MERCUISER SERVICE BULLETIN

Number: 19

Date : 9/29/64

A. MERCUISER II POWER TILT INSTALLATION

Figure 1. Reverse Hook Assembly Spring

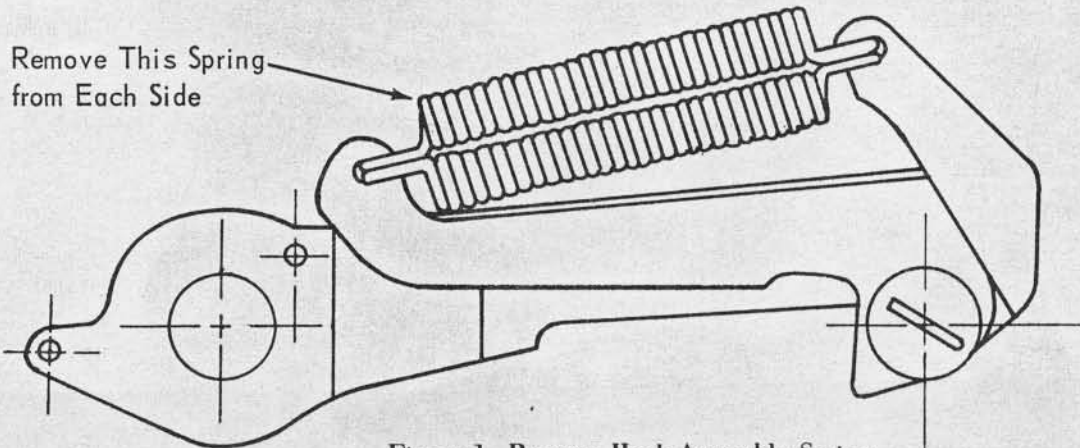
When installing Power Tilt on MerCruiser II Stern Drive Units, Serial No. 1778954 and above, remove one spring on each side of reverse hook assembly, as shown in Figure 1.
